**MICROCHIP****PIC18F2420/2520/4420/4520****PIC18F2420/2520/4420/4520 Rev. B2 Silicon Errata**

The PIC18F2420/2520/4420/4520 Rev. B2 parts you have received conform functionally to the Device Data Sheet (DS39631C), except for the anomalies described below. Any Data Sheet Clarification issues related to the PIC18F2420/2520/4420/4520 will be reported in a separate Data Sheet errata. Please check the Microchip web site for any existing issues.

The following silicon errata apply only to PIC18F2420/2520/4420/4520 devices with these Device/Revision IDs:

**FIGURE 1: SCK PULSE VARIATION USING TIMER2/2**

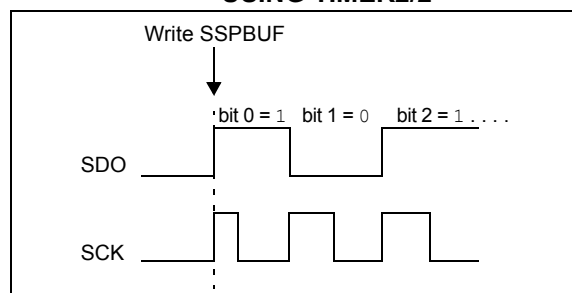
### 8. Module: MSSP (SPI Mode)

When the SPI is using Timer2/2 as the clock source, a shorter than expected SCK pulse may occur on the first bit of the transmitted/received data (Figure 1).

To avoid producing the short pulse, turn off Timer2 and clear the TMR2 register, load the SSPBUF with the data to transmit and then turn Timer2 back on. Refer to Example 2 for sample code.

```
LOOP BTFSS SSPSTAT, BF    ;Data received?
                                ; (Xmit complete?)
    BRA     LOOP            ;No
    MOVF    SSPBUF, W        ;W = SSPBUF
    MOVWF   RXDATA          ;Save in user RAM
    MOVF    TXDATA, W        ;W = TXDATA
    BCF     T2CON, TMR2ON    ;Timer2 off
    CLRF    TMR2            ;Clear Timer2
    MOVWF   SSPBUF          ;Xmit New data
    BSF     T2CON, TMR2ON    ;Timer2 on
```
